# UNITED STATES PATENT AND TRADEMARK OFFICE

APPLICATION NO.	FILING DATE	FIRST NAMED INVENTOR	ATTORNEY DOCKET NO.	CONFIRMATION NO.
10/771,753	02/04/2004	Robert Watz	DT-6710	3677
36377 7590 12/11/2007 DAVID TOREN, ESQ. ABELMAN FRAYNE & SCHWAB 666 THIRD AVENUE NEW YORK, NY 10017-5621			EXAMINER EASTMAN, AARON ROBERT	
			ART UNIT 4147	PAPER NUMBER
			MAIL DATE 12/11/2007	DELIVERY MODE PAPER

# Office Action Summary

Figure 4a of Instant Application 10771753

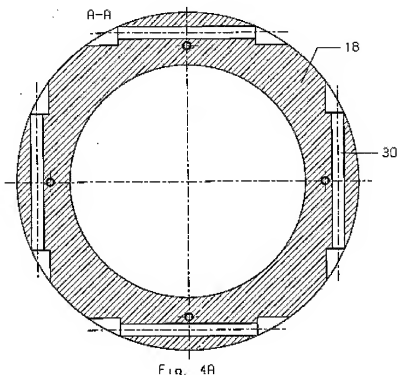
Claim 4 is rejected under 35 U.S.C. 112, first paragraph, as failing to comply with the enablement requirement. The claim(s) contains subject matter which was not described in the specification in such a way as to enable one skilled in the art to which it pertains, or with which it is most nearly connected, to make and/or use the invention. Claim 4 discloses, "...a plurality of bores formed in the component and extending each in a respective tangential direction." This is not supported by the specification, particularly

Figure 4a (see below), when the ordinary meaning of tangent is used as defined by the Merriam-Webster on-line dictionary ([www.m-w.com](http://www.m-w.com)) "meeting a curve or surface in a single point if a sufficiently small interval is considered".

Figure 1 of Ichikawa et al.

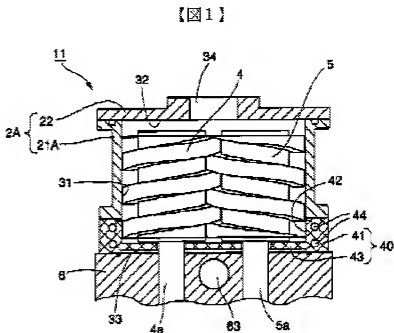
5. In re claim 1, Ichikawa et al. discloses:

"A vacuum pump (11), comprising a flange (21a) provided on a suction side of the pump for connection with a connection flange of a recipient (22), and a tempering component (40)" but does not disclose "a tempering component to be arranged between the suction side flange of the pump and the recipient connection flange and including tempering means."

6. It would have been obvious to one having ordinary skill in the art at the time the invention was made to move the tempering component so that it is arranged between the suction side flange of the pump and the recipient connection flange in order to cool the air that passes through that area.

"A vacuum pump as set forth in claim 1, wherein the tempering means comprises a plurality of bores (44, Fig. 1) formed in the component and extending each in a respective tangential direction" as tangent is best understood by the examiner.

Figures 2a, 2b and 2c of Ichikawa et al.

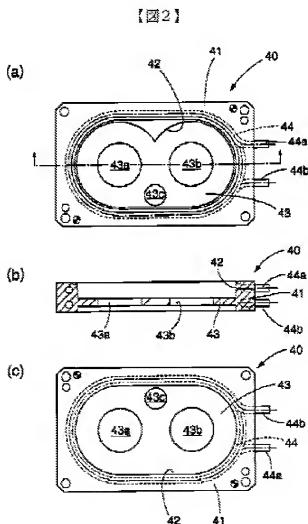
7. In re claim 2, Ichikawa et al. discloses:

"A vacuum pump as set forth in claim 1, wherein the tempering means comprises a circumferential groove (41) provided on the component, and a hollow body (44) received in the groove."

8. Again, while Ichikawa et al. does not disclose a tempering component to be arranged between the suction side flange of the pump and the recipient connection flange, it would have been obvious to one having ordinary skill in the art at the time the invention was made to move the tempering component so that it is arranged between the suction side flange of the pump and the recipient connection flange in order to cool the air that passes through that area.

Figure 1 of Hettinger

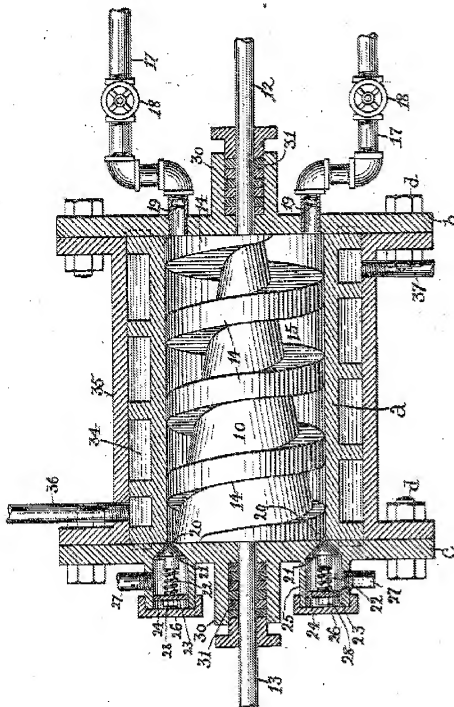
14. In re claim 3, Ichikawa has been discussed above as disclosing "A vacuum pump as set forth in claim 1" but does not disclose "wherein the tempering means comprises a circumferential groove provided on the component, and a hollow body received in the groove" as set forth in the claim. Hettinger discloses: "... tempering means comprises a circumferential groove (34) provided on the component (a), and means for closing the groove comprising a sleeve (35) and sealing means (d)."

15. It would have been obvious to one having ordinary skill in the art at the time the invention was made to combine the cooling means taught in Hettinger with the vacuum pump taught in claim 1 as disclosed by Ichikawa et al. in order to effectively cool the pump.

**Figure 1 of Reimer**

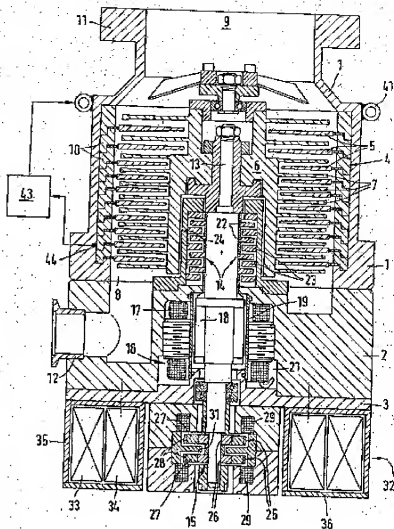
17. In re claim 6, Ichikawa has been discussed above as disclosing "A vacuum pump as set forth in claim 1" but does not disclose "further comprising temperature control means connected with the tempering means" as set forth in the claim. Reimer discloses: "...temperature control means (43) connected with the tempering means (41)."

18. It would have been obvious to one having ordinary skill in the art at the time the invention was made to combine the temperature control means taught in Reimer with the vacuum pump taught in claim 1 as disclosed by Ichikawa et al. in order to regulate the temperature of the cooling fluid.

Figure 1 of Spencer (partial view)

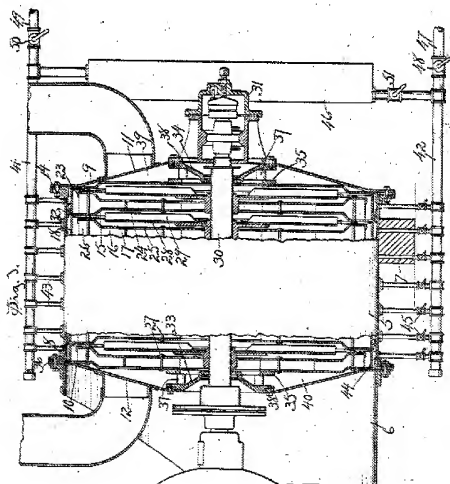
20. In re claim 7, Ichikawa has been discussed above as disclosing "A vacuum pump as set forth in claim 1" but does not disclose, "a plurality of tempering components is provided between the suction side flange and the recipient connection flange" as set forth in the claim. Spencer discloses: "...a plurality of tempering components (comprising 42-51) is provided between the suction side flange and the recipient flange."

21. It would have been obvious to one having ordinary skill in the art at the time the invention was made to combine the plurality of tempering components taught in Spencer with the vacuum pump taught in claim 1 as disclosed by Ichikawa et al. in order to maximize the cooling effect.
